RIZZO ASSOCIATES, INC.

December 14, 1988

Re: New Bedford Harbor

1. HOT SPOT REMEDIAL ACTION

Figure 1. Location of proposed protective gravel cap in the upper estuary.

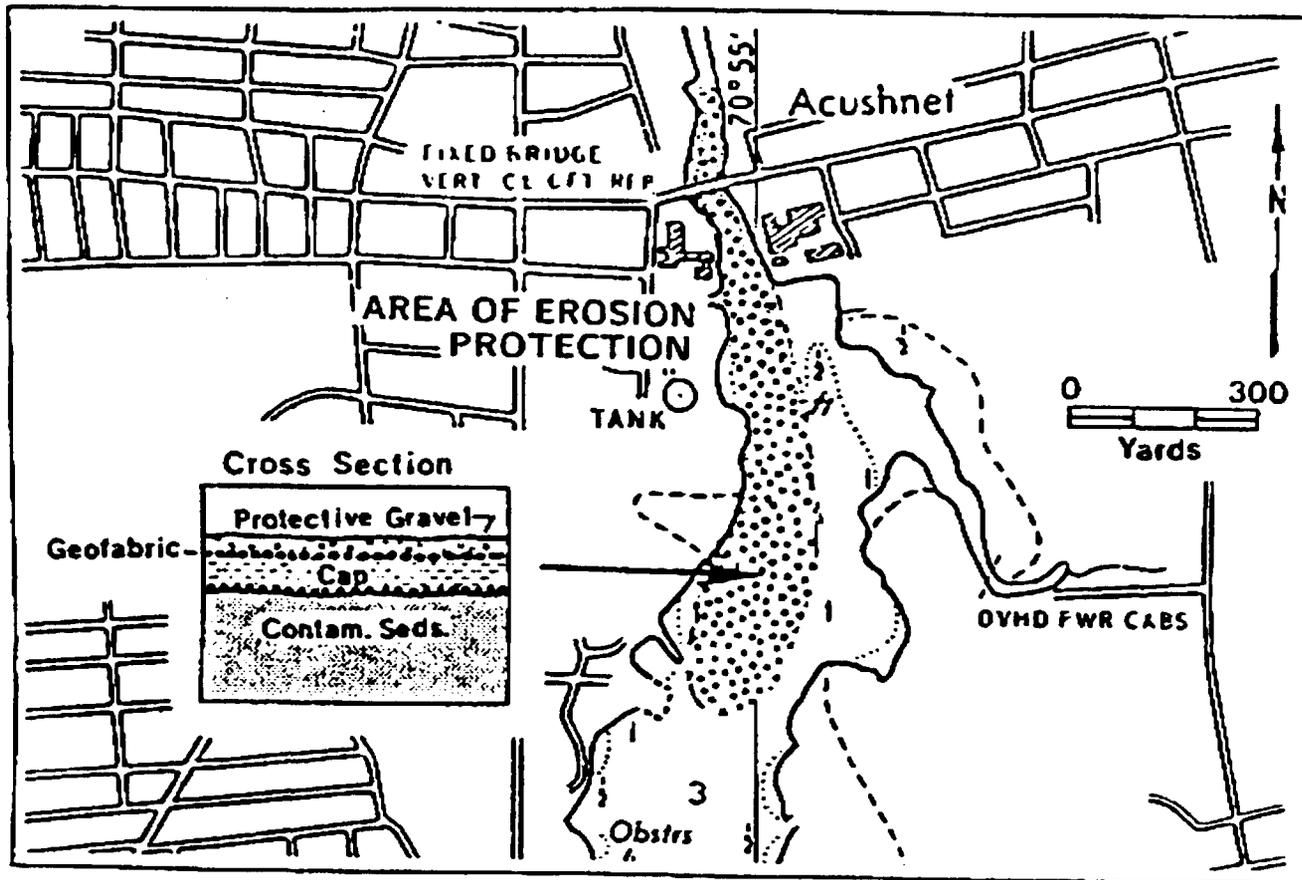
Provide technical backup for the decision to require a 45-cm-thick cap. What is the proposed cap placement method? What is the target cap thickness that will be utilized to ensure that the design thickness will be achieved, as a minimum, throughout the capped area?

With capping included, channel sections 4 through 8 (Figure 1) have velocities that exceed the threshold for cap sediment (fine to medium sand) erosion (≥ 30 cm/sec). Hence, capping material in this area will be subject to erosion during the storm. It should be noted that a typical storm has a duration of 5-7 hours and hence the period of time that the cap will be subject to erosion is extremely limited.

For the area identified as needing erosive protection (Figure 1, 18 acres), it is proposed to perform all cap placement "in the dry." In this approach, the area would be isolated from the remainder of the estuary by wooden sheet pile

Cap thickness can be accurately controlled in this area by the use of vertical reference stakes driven into the sediments. This is a well-established, widely used, simple procedure to control placement of the cap. It is anticipated that the sand cap thickness will vary between 45 and 60 cm in this area with the minimum set at 45 cm.

A combination of a protective cap in the present river channel (Figure 1) and the establishment of cord grass on the intertidal and above mean high water areas will protect the cap from this brief storm-induced erosion event. The size of the protective cap material (gravel) can be selected to provide adequate erosion protection. In areas of higher velocity, the gravel size becomes coarser. In extremely high velocity areas, pea stone, trap rock or even small size rip-rap can be used to provide additional protection.
